**ARLINGTON 425 – PC#: 19-001**  
**PETITIONER RESPONSES TO ROUND 3 COMMENTS**  
**APRIL 3, 2019**

**RESPONSES TO FIRE SAFETY DIVISION COMMENTS**

Re: Arlington 425

Job No: 18-127 Figure: A

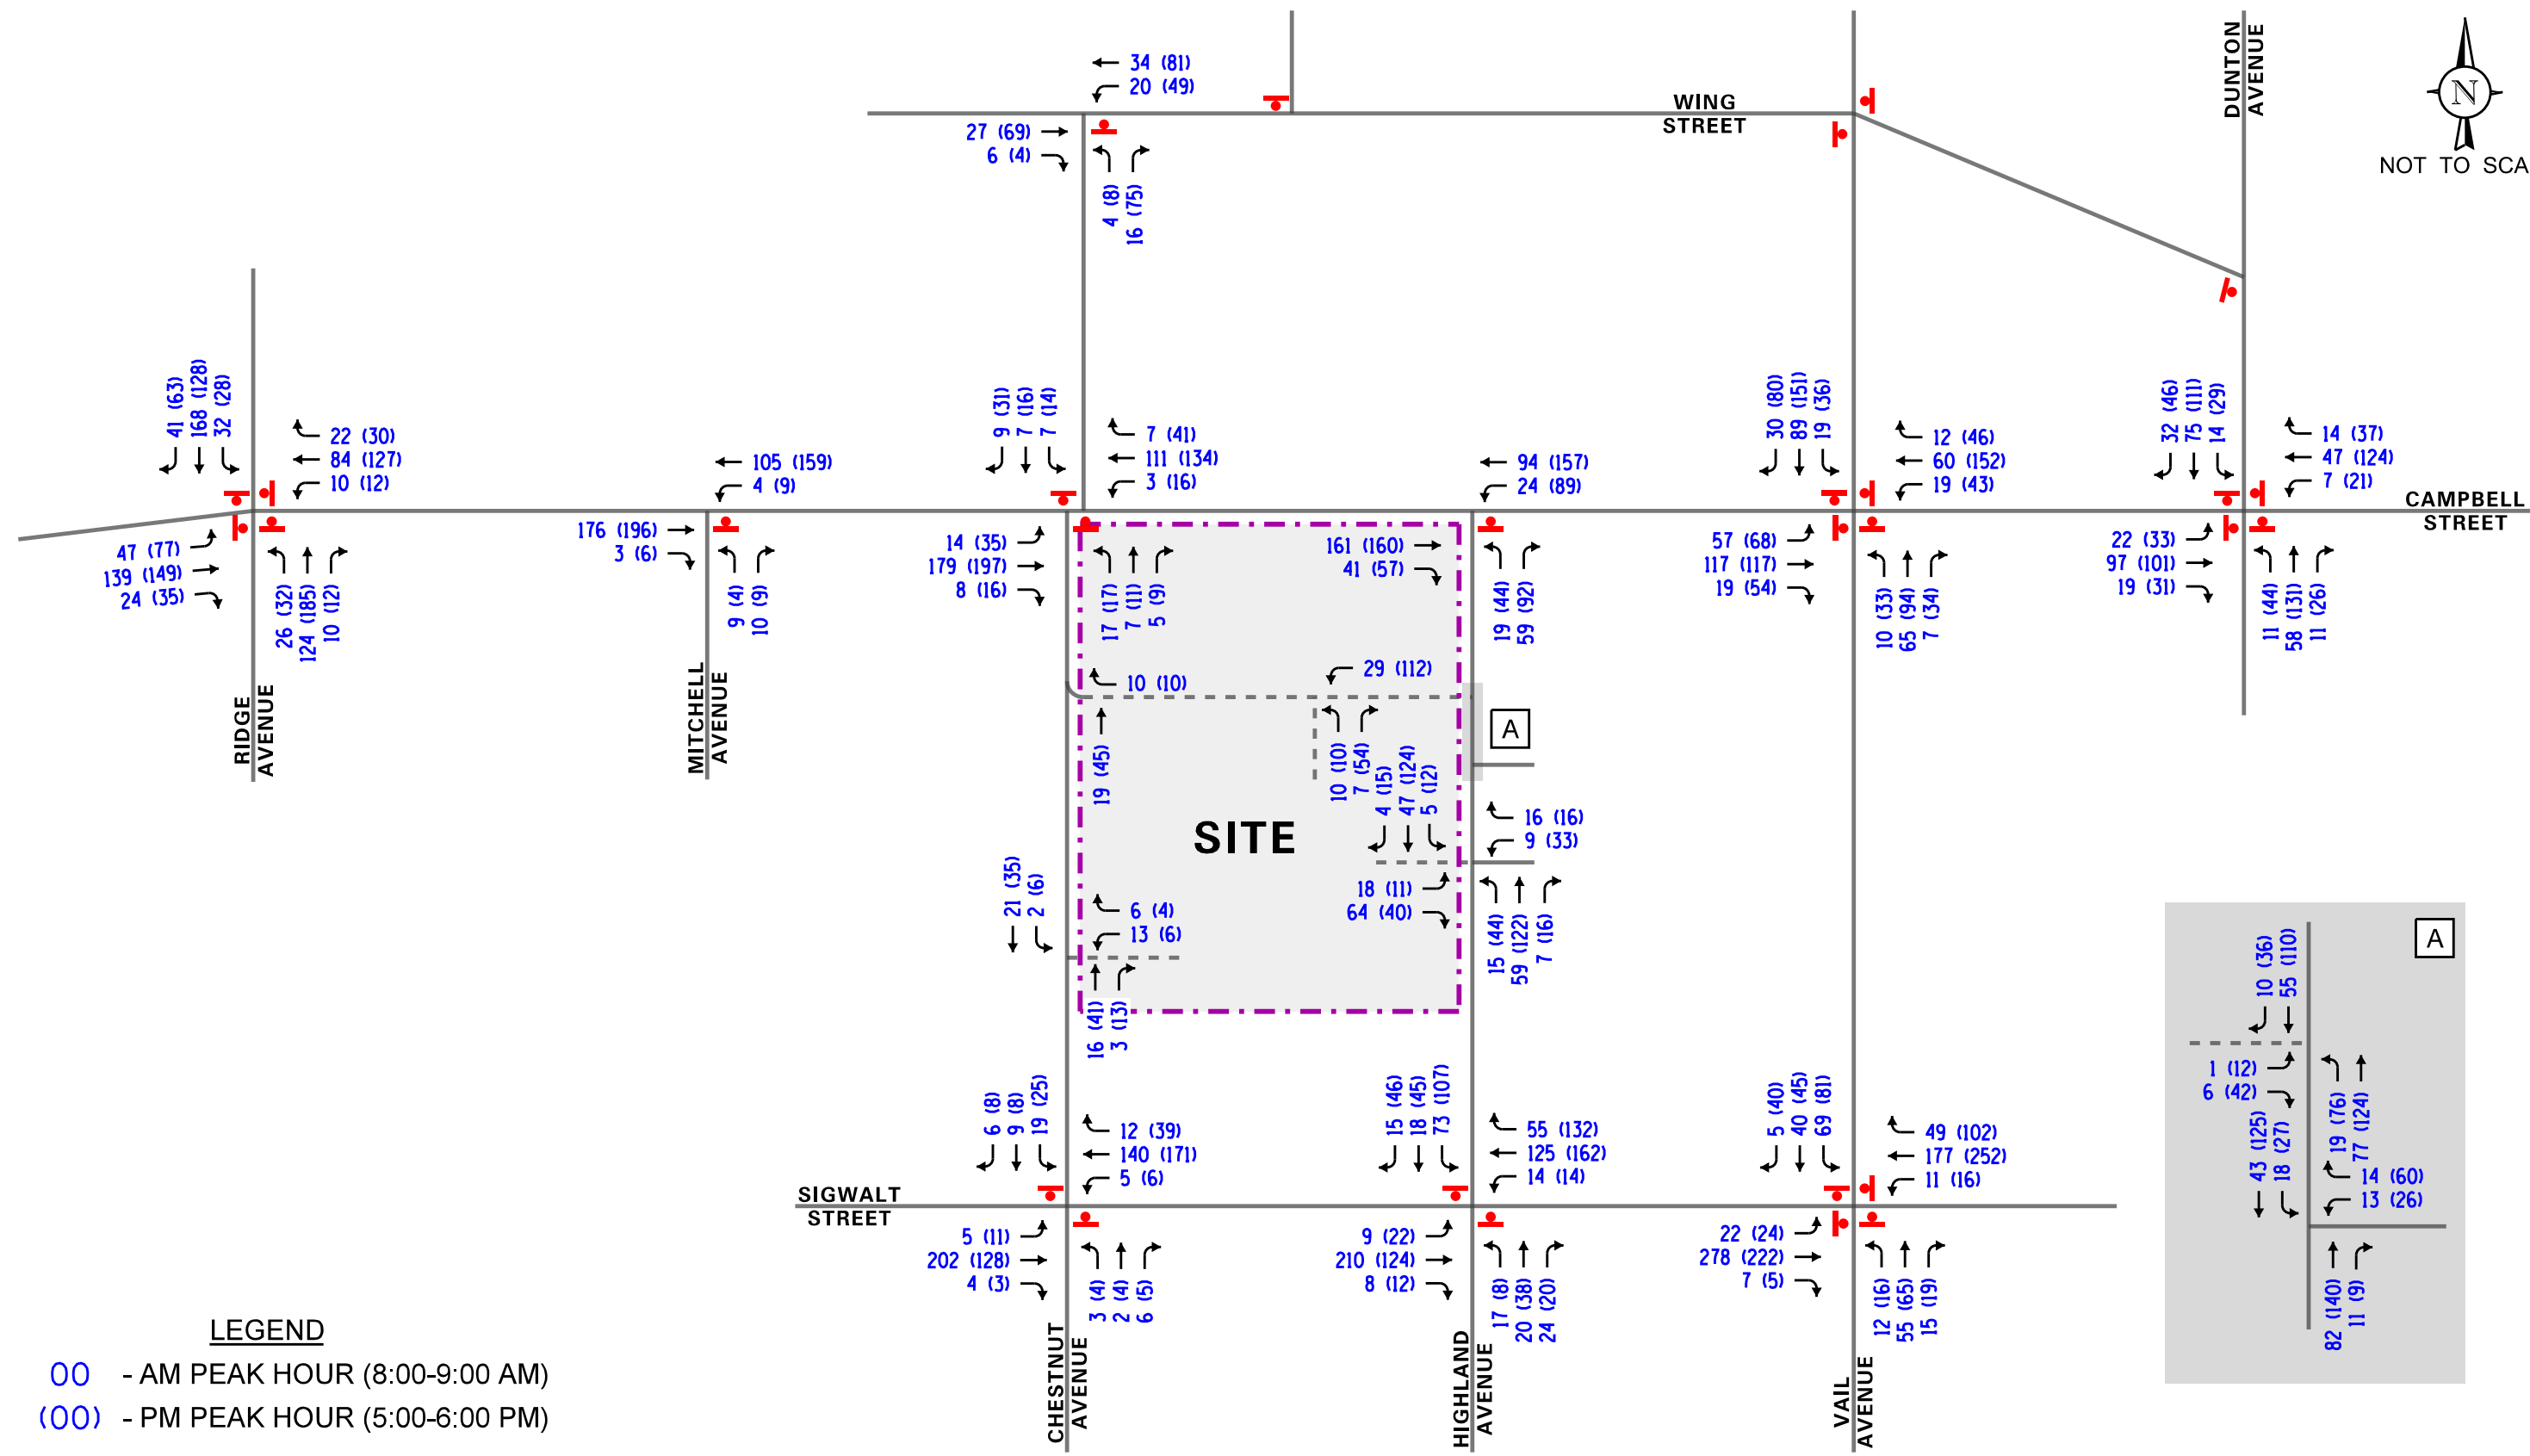
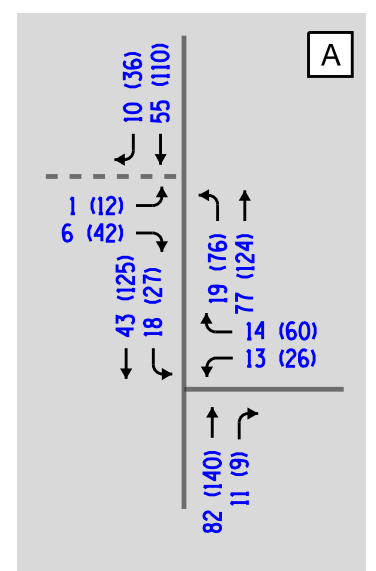
95. Provide revised traffic distribution data assuming that the driveway off Campbell is eliminated and the driveway off Highland is two way.

*Response:* Traffic was redistributed assuming no access on Campbell Street and the access on Highland allows two-way traffic flow. Please see Figure A of the revised traffic study, which shows the total projected traffic volumes assuming this development access configuration. Please also see Table 1 of the revised traffic study, which shows the projected levels of service for the respective intersections that assumes all-way stop sign control on Highland Avenue with Campbell Street and Sigwalt Street. As shown, these intersections are projected to operate at acceptable levels of service assuming this development access configuration.

93. As noted, the basement space is storage only and does not factor into the parking calculations for residential parking.
95. Traffic was redistributed assuming no access on Campbell Street and the access on Highland allows two-way traffic flow. Attached is Figure A, which shows the total projected traffic volumes assuming this development access configuration. Also attached is Table 1, which shows the projected levels of service for the respective intersections that assumes all-way stop sign control on Highland Avenue with Campbell Street and Sigwalt Street. As shown, these intersections are projected to operate at acceptable levels of service assuming this development access configuration.
